SURFACE WATER DRAINAGE DISCHARGE OF CONDITIONS

Ref: MC0539 Naldrett Elmer Road DOC

- 1.1 Meridian Civil Engineering Consultancy LTD (MCEC) has been instructed by Martin Naldrett to prepare a document pack to collate information required for addressing a planning condition, Planning ref: M/39/24/DOC with Arun District Council. The proposals are for the construction of 2x semi-detached dwellings.

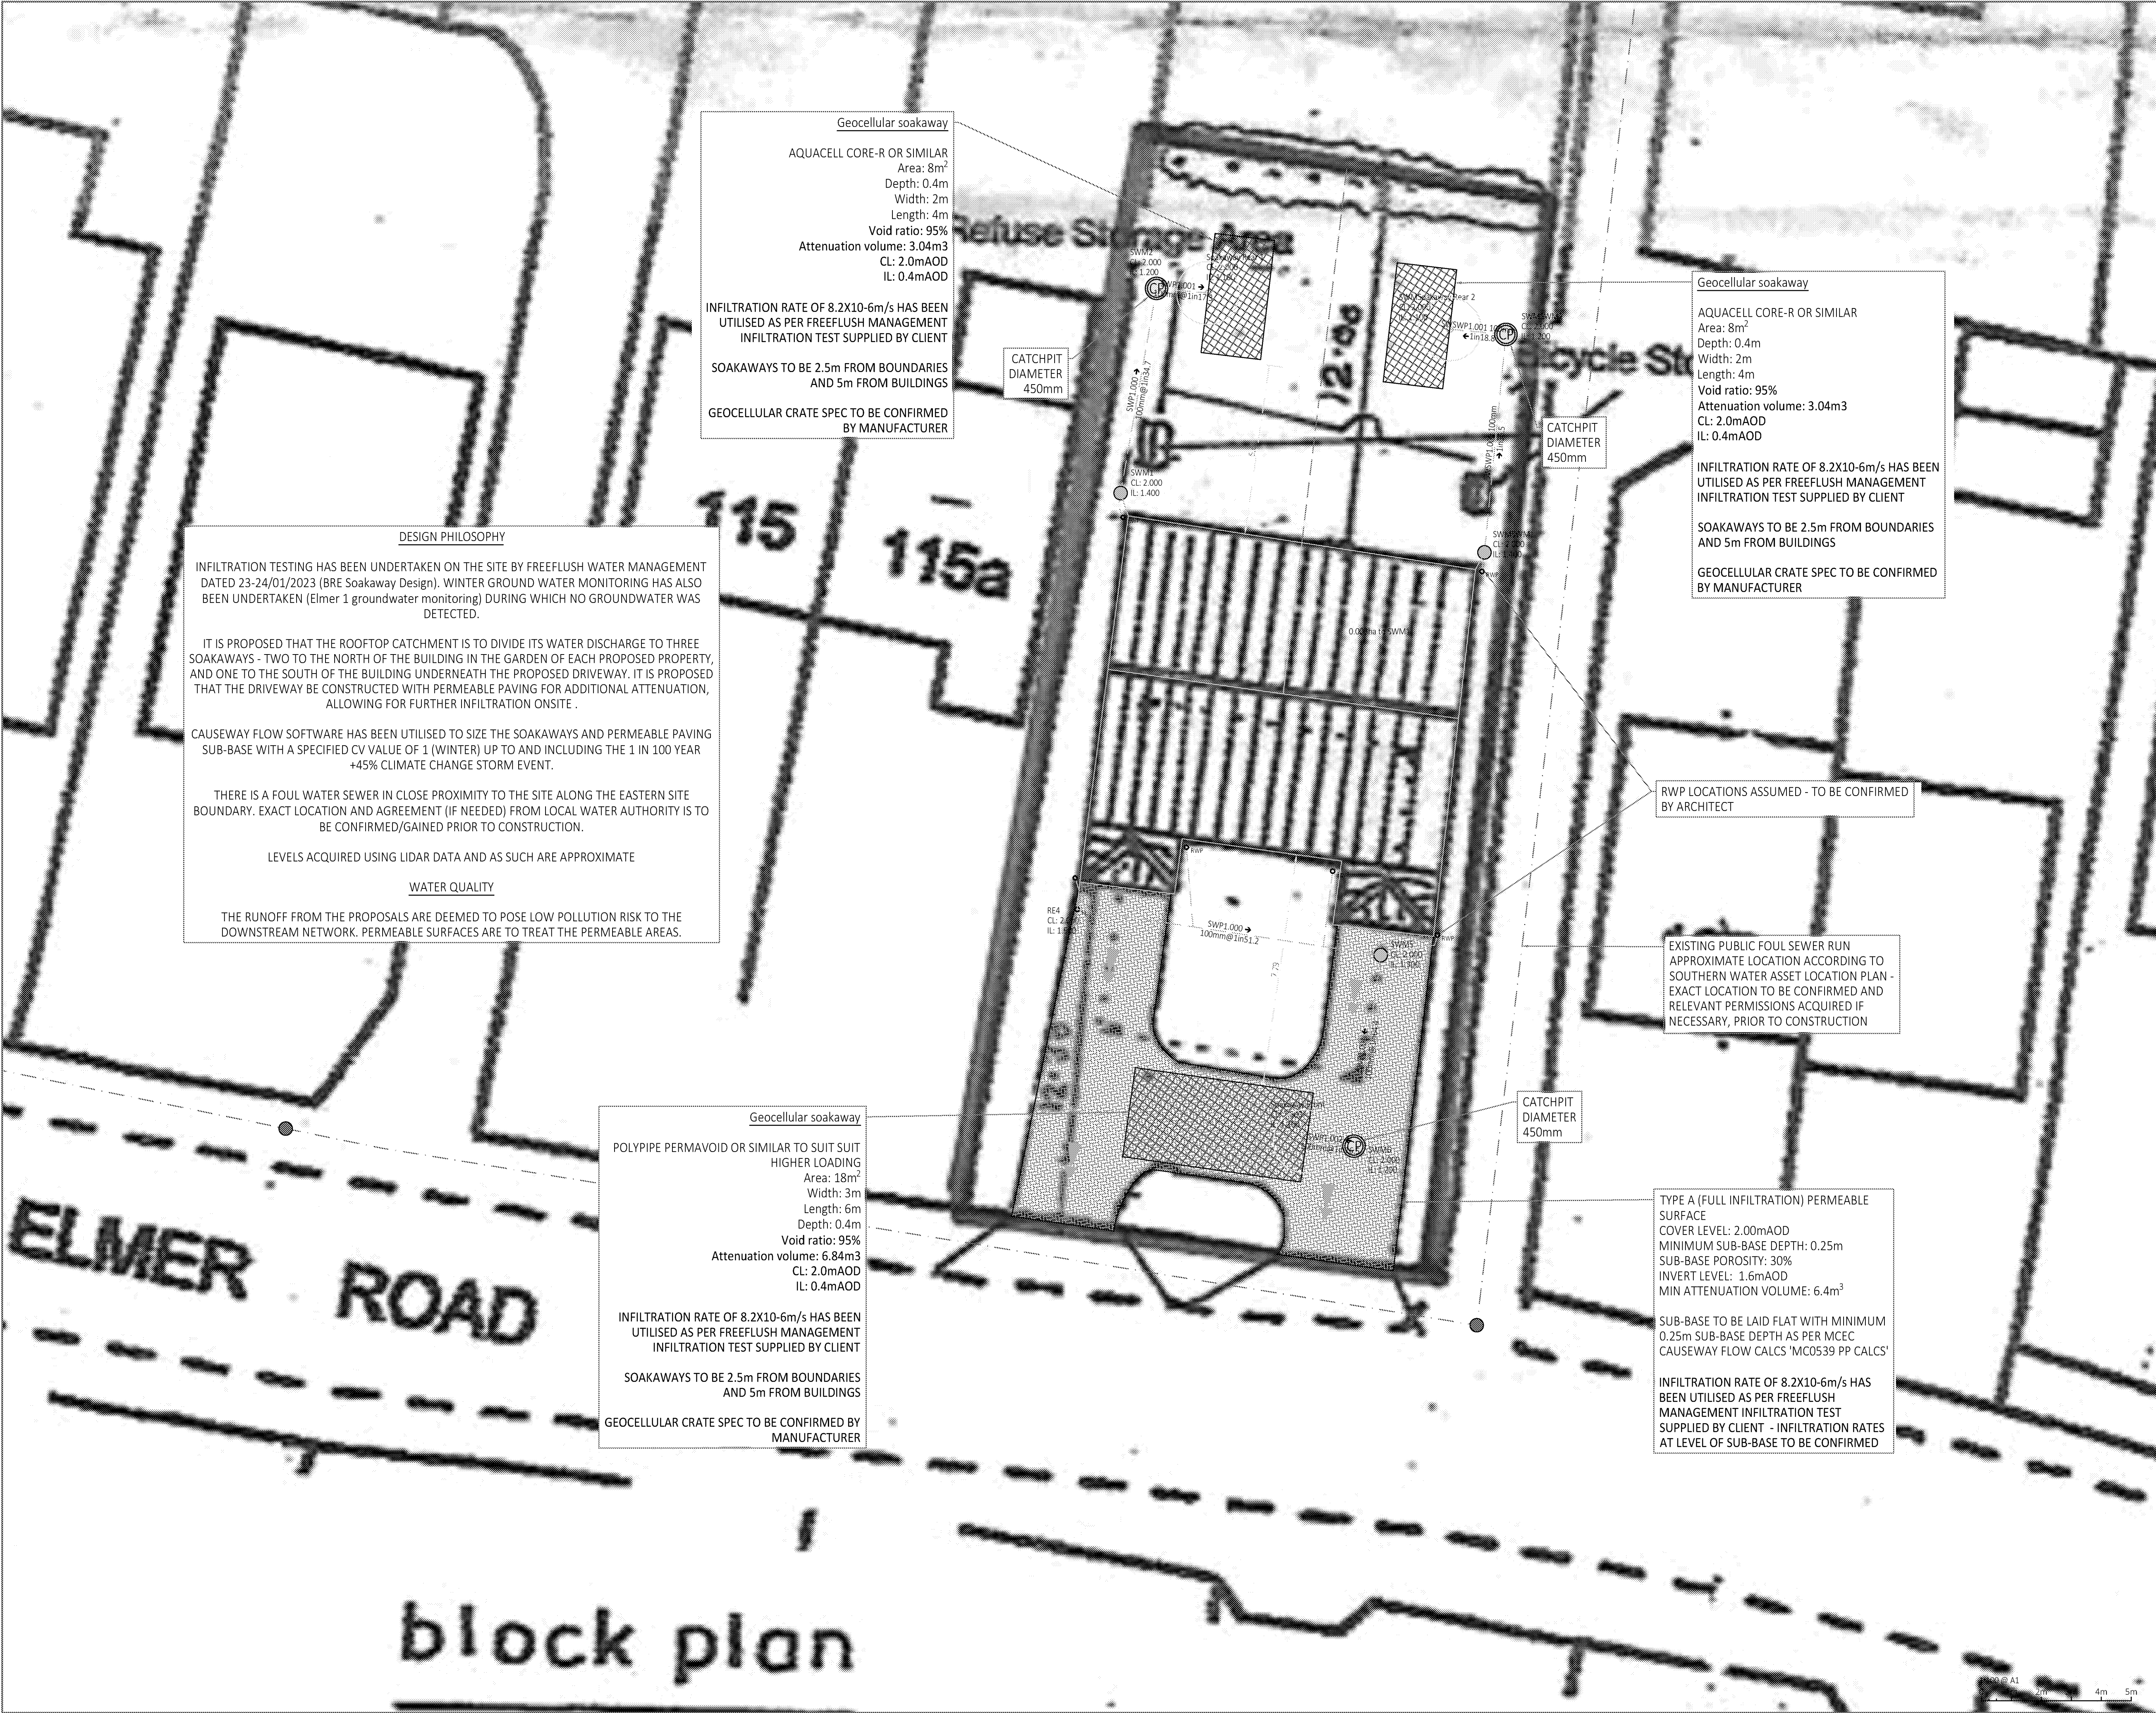
Comment Number	Drainage Condition	MCEC comment
5	<i>Please see comments 14, 17, 19, 20-23 below.</i>	See MCEC comments for 14, 17, 19 20-23 below.
6	<i>Provided – see comments 14, 15, (19), 22, (23), 26-28 below.</i>	See MCEC comments for 14, 15, 19, 22, 23, 26-28 below.
8	<i>Summer CV is 0.75, please correct to 1.</i>	Summer CV has been set to 1, and resulting changes have been made to the drainage design to account for the increase in runoff from the original CV setting. See attached CIV01 drawing for adapted drainage design, as well as Appendix II for accompanying calculations.
10	<i>Gradients provided. Pipe upstream of SWM1 does not include gradient and is likely steeper than 1 in 100 as described by the notes.</i>	Drainage design has changed, therefore rectifying the issue raised concerning pipe gradients. See attached CIV01 drawing for adapted drainage design, as well as Appendix II for accompanying calculations.

14	<i>'Notes state 'or similar'. The exact crate must be specified, or the specifications of an alternative. Is capable of withstanding vehicular loading at 1.2m depth.</i>	Crate specifications have been provided for the front and rear soakaways which reflect their structural requirements.
15	<i>Please also label the membrane below the tarmacadam on the permeable paving detail.</i>	Amended – see CIV02 for construction detail.
17	<i>Why is there no rodding eye or inspection chamber north of the proposed 117a at the junction of the RWP? Upstream of SWM1.</i>	Drainage design has changed, therefore rectifying the issue raised concerning the absence of rodding eye or inspection chamber at this location. See attached CIV01 drawing for adapted drainage design.
18	<i>The design has changed to two (rather than 4) soakaways. These are in the centre of the divided front and rear gardens. How will management and maintenance be organised between the future homeowners?</i>	Proposal has been altered to address this concern. There are now two rear soakaways – each proposed in garden of the properties, and safely positioned (at least 5m away from any building, and at least 2.5m away from any boundary). See attached CIV01 drawing for adapted drainage design.

19	<i>Please provide a plan and details showing how that the new design for the rear soakaways will not be structurally impacted by the boundary treatments – particularly in the rear gardens.</i>	Updated drawing includes an assumed boundary line and two rear soakaways rather than one combined across the two proposed properties. This indicates how the rear soakaways will not be structurally impacted by the boundary treatments. See attached CIV01 drawing for adapted drainage design.

20	<i>Suggested: include dimensions of the soakaways rather than just plan areas.</i>	Additional length and width dimensions have been included in the Soakaway notes in addition to total plan areas and depths – see attached CIV01 drawing.
21	<i>Soakaways must be set at 1.2m below ground level to accord with the infiltration testing (see point 1). Therefore, the soakaways must be set deeper.</i>	All proposed soakaways have been set at the requested depth, with drainage redesigned to account for this change. See attached CIV01 drawing for adapted drainage design, as well as Appendix II for accompanying calculations.
22	<i>Soakaway base levels appear to not be consistent between the construction details and the layout. It is assumed that the IL labelled directly next to the soakaways related to the incoming pipe invert levels. Please Clarify. It is suggested that the incoming pipe invert level, or the base of the soakaway are labelled with different notation on the layout to avoid confusion.</i>	Drawing annotations have been altered to provide clarity – see attached CIV 01 drawing.

23	<i>Suggested: A link could be provided between the permeable paving subbase with a diffuser unit connected to SWM6 so the the two systems are linked to maximise infiltration and storage. This is suggested on the basis of a lack of design infiltration rate at the proposed depth of the now formal permeable paving construction.</i> <i>If provided, please provide a construction detail drawing, to include base level of diffuser and invert level at the point of connection of the catchpit.</i>	MCEC have opposed this suggestion. The roof runoff area has been designed to run directly into the soakaways to allow for a greater than 5m proximity to the building for infiltration. Use of diffuser units would not be possible or safe to implement as infiltration would be promoted less than 5m from the building, possibly compromising its long-term structural integrity.
24	<i>Climate Change allowance for the 1% AEP event must be 45%.</i>	Climate change allowance for the 1% AEP event has been increased from 40% to 45% for drainage calculations. See Appendix II for accompanying calculations.

CATCHPIT INSPECTION CHAMBER

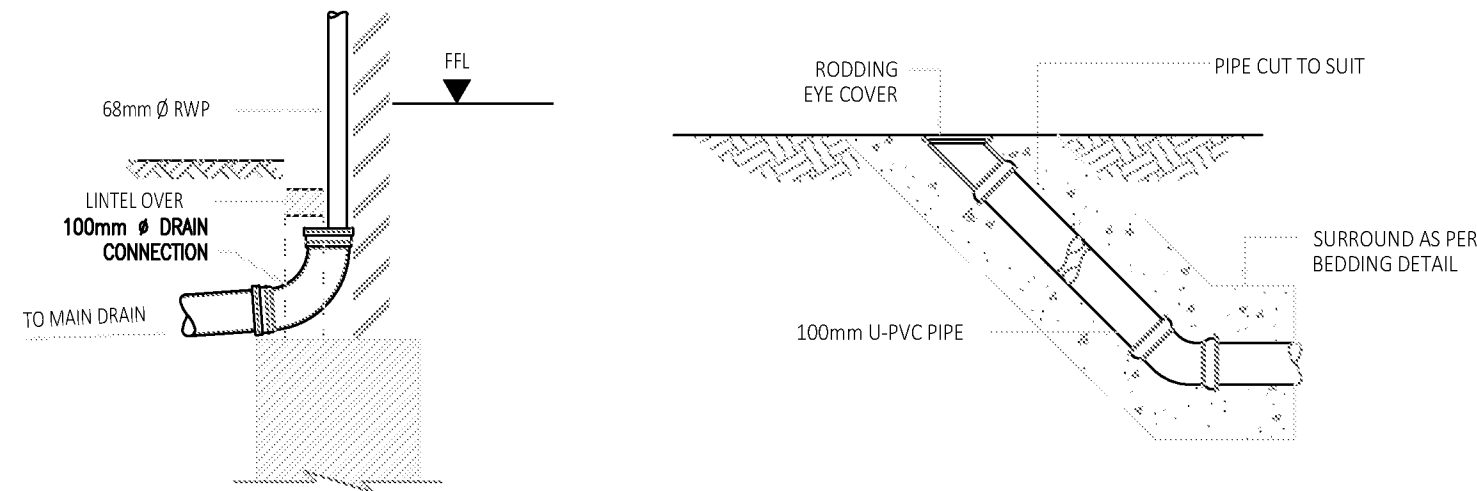
25	<i>Please provide 10%+CCA and 3.33%+CCA calculations.</i>	The 10%+CCA and 3.33%+CCA events have now been included as part of the provided calculations. See Appendix II for accompanying calculations.
26	<i>Please specify catchpit diameter.</i>	Annotations have been included in the CIV01 drawing which detail the designed catchpit diameters.
27	<i>Typical crate soakaway refers to a slotted pipe, it is not clear why. Please adjust.</i>	Typical Crate Soakaway detail in CIV02 has been amended.
28	<i>Rodding eye detail, the pipe diameter needs to be corrected to</i>	Rodding Eye Detail in CIV02 has been amended.

RODDING EYE DETAIL

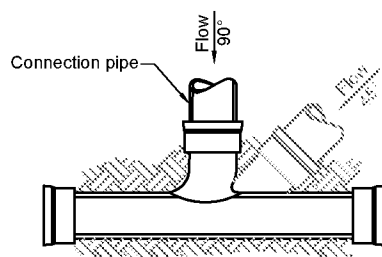
<i>100mm in accordance with the design.</i>	
29	<i>The design infiltration rate has been applied to the base and sides of the soakaways and permeable paving in the calculations. Please apply to the base OR the sides, not both.</i> <i>The design infiltration rate must be 0.02952m/hr or 8.2x20-6m/s.</i>	The design infiltration rate of 0.02952m/hr has been applied to only the base of each proposed soakaway, with no side infiltration used in the calculations. See Appendix II for accompanying calculations.
30	<i>Please provide construction detail for oblique pipe to pipe connections/junctions.</i>	Oblique Pipe Junction detail has been added to CIV02.
31	<i>Please illustrate exceedance flow routes.</i>	Exceedance flow routes have been illustrated on the front driveway – see attached CIV01 drawing.
